# SERVICE BULLETIN

\* Supersedes SB600N-023, dated 05 April 1999. **Reason for Revision:** Extend compliance time. Aircraft which have complied with SB600N-023 meet the intent of this revision.

## CYCLIC STICK REPLACEMENT

All model 600N helicopters, serial number RN003 thru RN051.

**Figure 1. Cyclic Stick Assembly Wiring Schematic.**

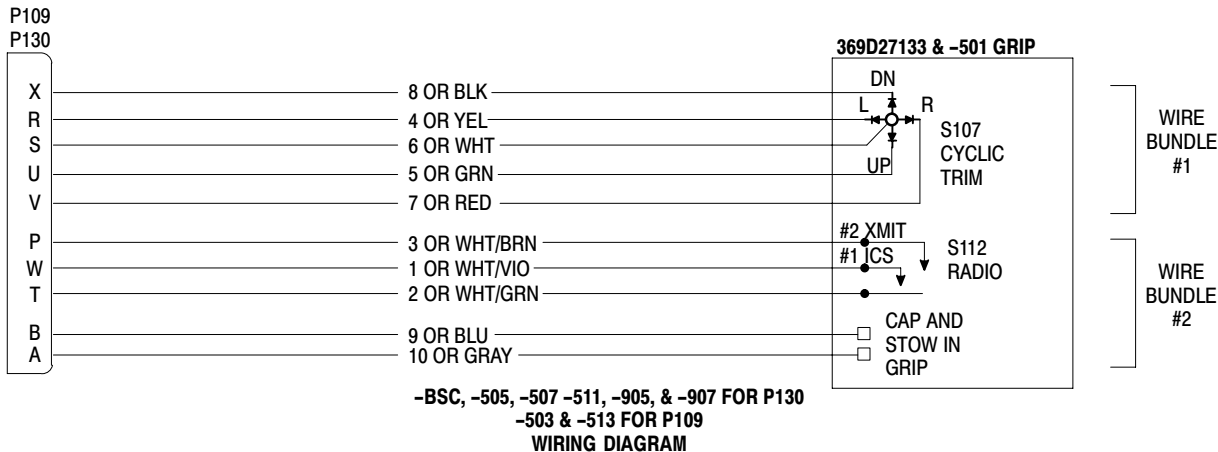
Refer to Figure 1 Wiring Schematic while performing the requirements of this Service Bulletin.

- (1). Remove cyclic control stick assemblies from the helicopter per instructions in the Handbook of Maintenance Instructions, Section 67-10-00.
- (2). Identify each wire harness subassembly before removing from cyclic assembly for ease on reinstallation (black, green, red, yellow, white) forward hole; (gray, blue, purple twist, green twist) aft hole.

- (4). Cut and discard P109/P130 plugs as close to the back of the plug as possible.
- (5). Remove cyclic grip from stick assembly by removing screw per the HMI, Section 67-10-20.

- (6). Carefully remove grip and wire harness from the cyclic stick assembly.
- (7). Reinstall the wire harness sub-assemblies into new stick assembly. Ensure proper location of previously identified wire harness subassemblies.

- (10). Using wire stripping tool and crimper, strip and crimp new pins onto wire harness.
- (11). Using insertion tool M81969/14-02 or equivalent, insert pins into the appropriate sockets of the connector (P/N MS3476W18-32P). Ensure pins have locked into the plug. Insert new red closeout plugs in unused sockets.

- (12). Assemble new connector (P109/P130). Position backshell onto plug.
- (13). As necessary, secure wire harness to stick assembly using tie straps.
- (14). Install cyclic stick assemblies into the helicopter per the HMI, Section 67-10-00.

- (8). Install cyclic grip to stick assembly per the HMI, Section 67-10-20.
- (9). Install new sleeving and new backshell (P/N M85049/55-18W) onto wire harness.
